Chief Executive's Report for Council Meeting 10th February 2024 SD24A/0187W

Reg. Reference: SD24A/0187W **Application Date:** 24-Jul-2024
Submission Type: Additional **Registration Date:** 22-Nov-2024
Information

Proposed Development: The construction of a 4-storey Primary Care Centre building which will provide HSE Services such as general primary care, mental health, disability and older person services; The building will accommodate GP rooms, day care centre with associated kitchen facilities and external deck amenity space, pharmacy, treatment/consultation rooms, primary care administrative offices, as well as ancillary accommodation including staff facilities, offices, meeting rooms, reception/waiting areas, ESB substation and plant; The development will be accessed via the existing avenue to the Citywest Campus entered from Garters Lane at the existing traffic light controlled junction, with a new internal road layout from the existing roundabout on the access avenue to provide 2 no. vehicular entrances to car parking within the subject site; The car parking will be divided into a dedicated staff car park and a visitor car park with both to be controlled by barrier access a

Figure 1: Citywest Primary Care Centre Catchment Map

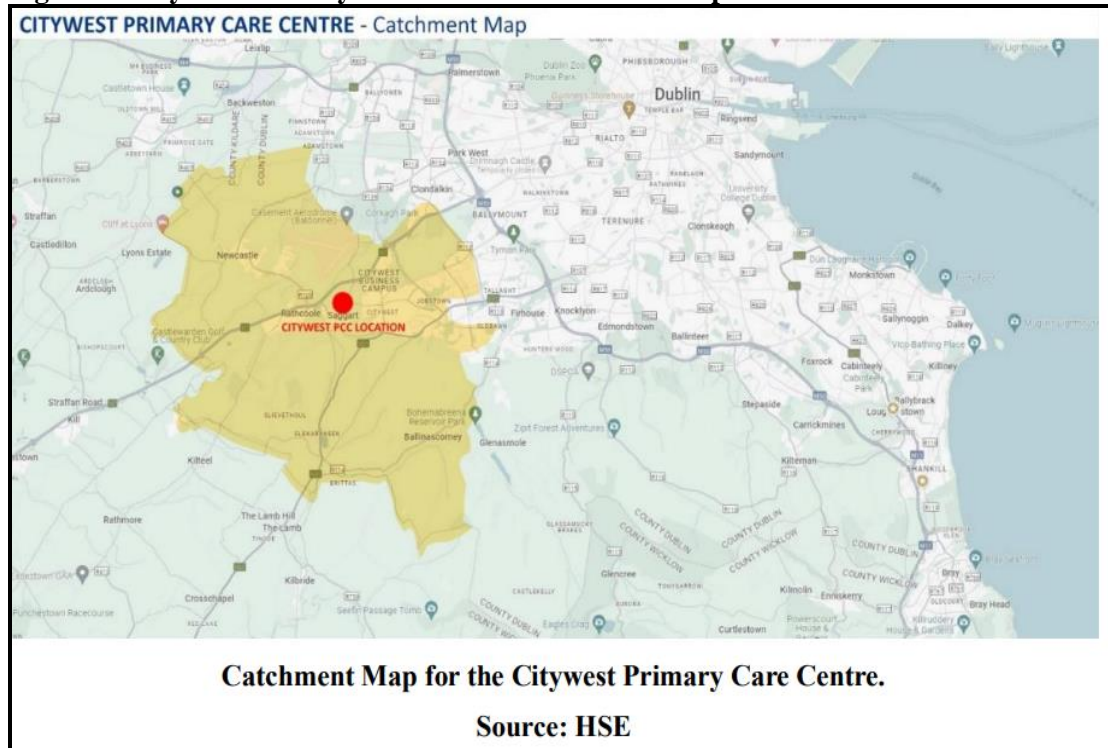
assessing this application is whether there are any alternative sites within the catchment area (see **Figure 1**) that could support the current proposal whilst continuing to meet all of the objectives of the Development Plan.

Figure 2: Site Analysis: Site Identification Map

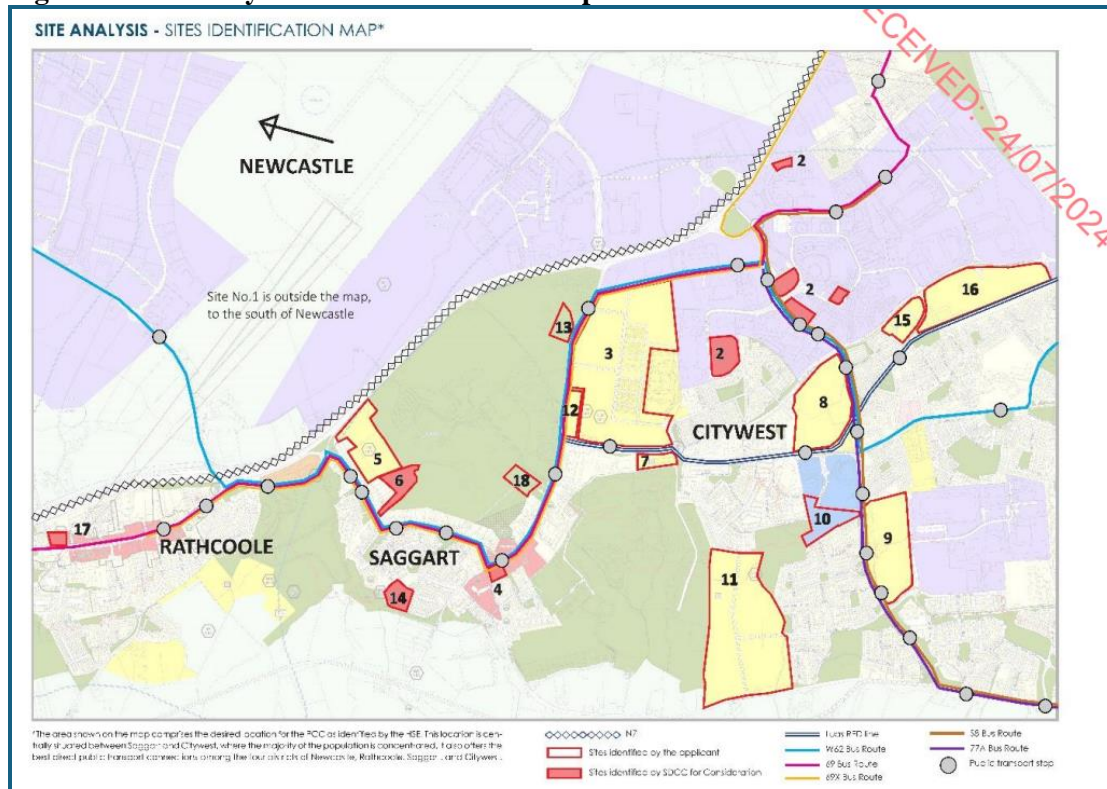
- **Site 1:** Site with existing footings for proposed Hotel in Newcastle. Site generally available for past 4 years. Zoned *RU* – site fails in relation to centrality (3), transport (5) and connectivity (6).

Having regard to the contents of the Site Selection Analysis and Justification Report, whilst the Planning Authority is satisfied with the six criteria chosen to assess the suitability or otherwise of the 18 sites chosen, questions still remain over Site 13 (Garter's Lane) given its similarities with the application site. Further justification for the exclusion of Site 13 is therefore needed. This information should be requested by way of **Additional information**.

- a. *The response from the applicant states:
"Option site 13 was considered by HSE under the criteria set for site selection, which included centrality in the district and accessibility. The proposed option site 18 has superior centrality and accessibility, with existing improved road infrastructure including safe pedestrian and cycle access already in place and proximity to developing neighbourhood facilities including schools etc.". The applicant also states that the urbanisation trend has been to the south and Site 13 is peripheral and comparatively inaccessible when compared to Site 18 and noted that Site 13 would require additional infrastructure to be put in place at considerable cost and may lead to significant impact on existing natural features. The applicant notes a number of policies and objectives in the CDP that would support the location of Site 18, namely CS6 Objective 5, Policy CS8: Saggart, CS8 Objective 3, Policy COS6: Healthcare Facilities, COS6 Objective 1 and COS6 Objective 3. In conclusion, the applicant states "It is submitted that a robust justification for the exclusion of Site 13 was provided in the Site Selection Analysis and Justification submitted at planning application stage and further detail has been provided in this response to confirm that the subject site is the only suitable site for the development".*

- a. The applicant has clarified the benefits of the chosen site over Site 13. The Planning Authority concurs with this assessment. The Planning and Development Act 2000 (as amended) gives the Planning Authority powers to support an application that materially contravenes the development plan in exceptional circumstances. Given the nature of the proposed use as a Primary Health Care Centre, together with the lack of available sites of suitable zoning, the Planning Authority is of the opinion that in this instance, the applicant has demonstrated that exceptional circumstances exist to support the proposal.
